## DESCRIPTIVE REPORT

*Registry No.* H-11069

*Sublocality* Offshore-East of Semidi Islands

# Descriptive Report to Accompany Hydrographic Survey H11069

Figure 1. Approximate Survey Limits of H11069

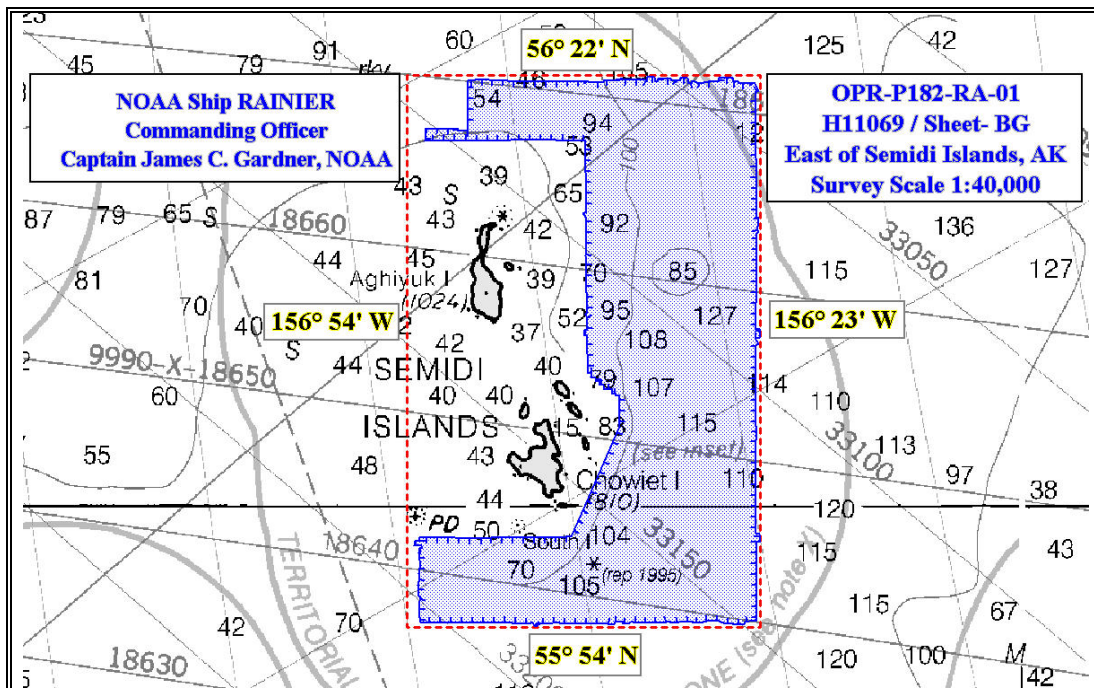
The survey area covers an offshore area east of the Semidi Islands and encompassing the northern and southern offshore extents of the Semidi Islands. H11069 is bounded on the west by approximate longitude  $156^{\circ} 54' 00''$  W, and on the east by approximate longitude  $156^{\circ} 23' 00''$  W. The northern and southern limits are latitudes  $56^{\circ} 22' 00''$  N and  $55^{\circ} 54' 00''$  N, respectively.

<sup>1</sup> PHB Revision: Actual limits are North: latitude 56°20'56"N; South: latitude 55°54'03"N, East: longitude 156°23'02"W; West: longitude 156°53'22"W.

Figure 2. H11069 Junction Surveys

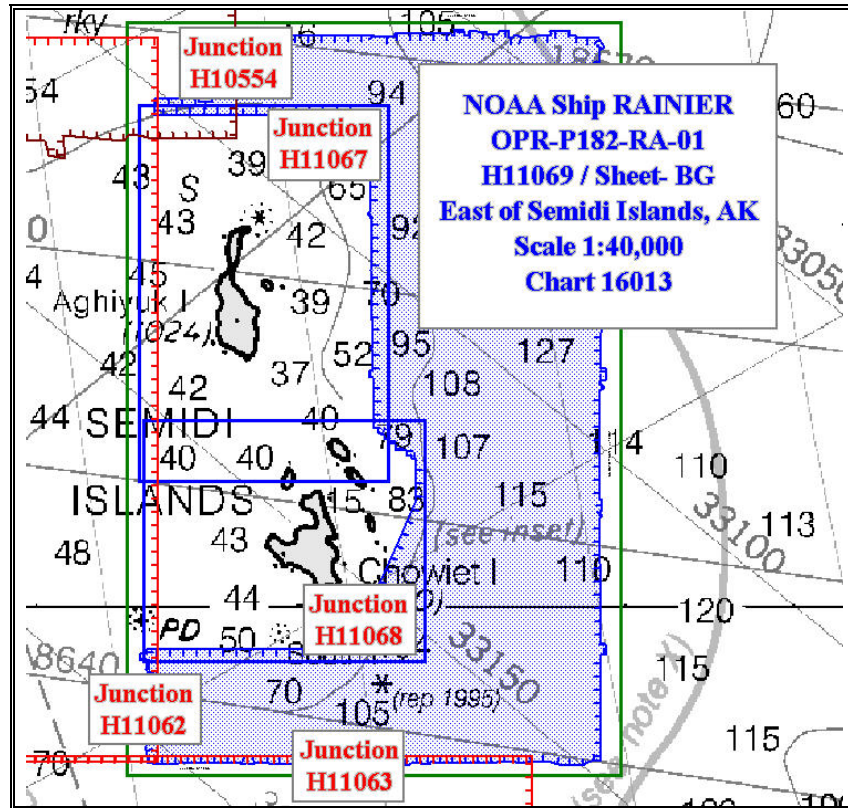
Vertical-beam echo sounder survey H10554, conducted by the NOAA Ship RAINIER in 1994, junctions with the northwest corner of this survey. The overall agreement was good: the average difference in soundings is zero to two meters where multibeam soundings overlay the vertical beam echo sounder smooth sheet soundings.<sup>5</sup> Additionally, survey soundings were shoaler between H10554 smooth sheet soundings even though agreement at the position of the charted depths was good.<sup>6</sup> This can be attributed to increased bottom coverage using SWMB methods.<sup>7</sup>

Contract surveys H11062 and H11063 were not completed prior to submittal of survey H11069. Junction comparisons with these surveys will be made at the Pacific Hydrographic Branch (PHB), N/CS34.<sup>8</sup>

<sup>5</sup> The junction with H-10554 was not formally completed since this survey was processed previously. A comparison of soundings between the surveys shows close agreement, generally within one to two fathoms, with survey H-10554 tending slightly shoaler. An "adjoins" note has been added to the smooth sheet.

<sup>8</sup> The junctions with contract surveys H-11062 and H-11063 are complete and "Joins" notes have been added to the smooth sheet where applicable. Agreement is good between these junctional surveys, within 0-2 fathoms, with the Rainier survey tending slightly shoaler than the contractor surveys.

Figure 4. H11069 Gross Chart Discrepancies

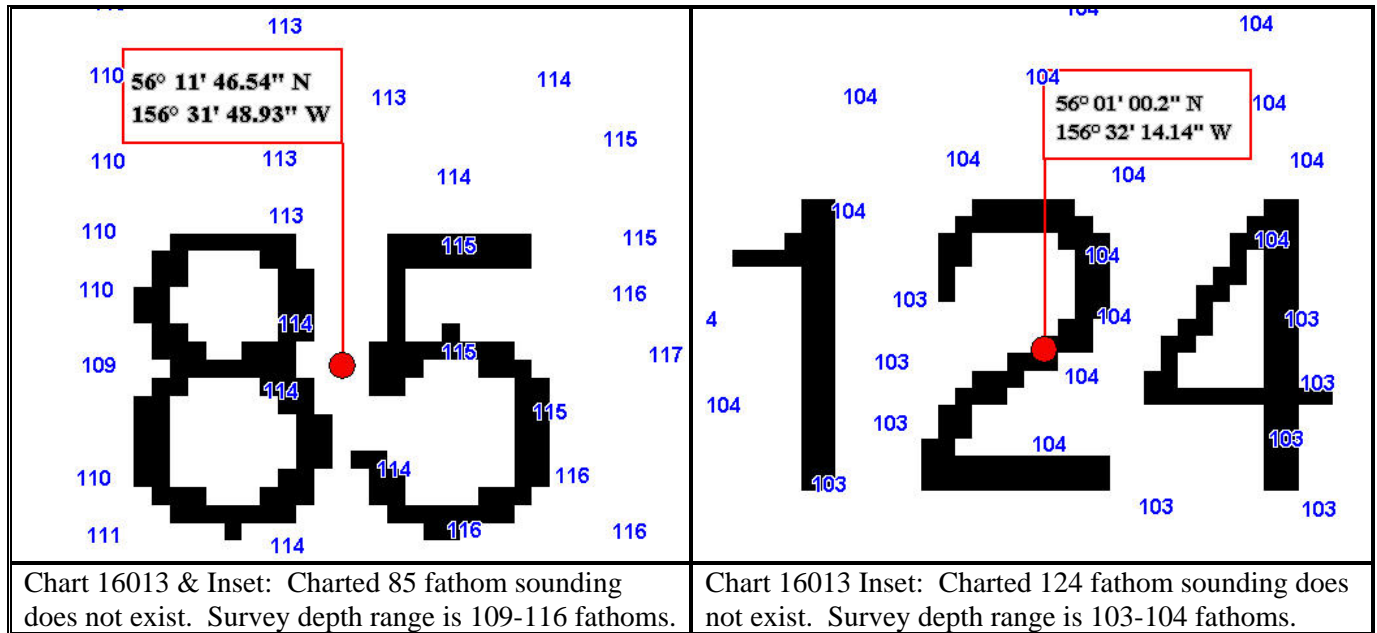
The overall agreement between the sparse charted soundings and survey depths is good. Most soundings compare within zero to two fathoms. However, two charted soundings with values of 85 fathoms and 124 fathoms had variances from survey depths of 24 and 21 fathoms respectively (see Figure 4).<sup>14</sup> All areas were covered with one hundred percent shallow-water multibeam.

<sup>14</sup> Corrected smooth sheet depth at the location of the 85 fathom sounding on the chart is 119-120 fathoms; on the inset is 114 fathoms. Corrected smooth sheet depth at the location of the 124 fathom sounding on the inset is 104 fathoms. Geoname placement precluded inclusion of the 124 fathom sounding on the chart.
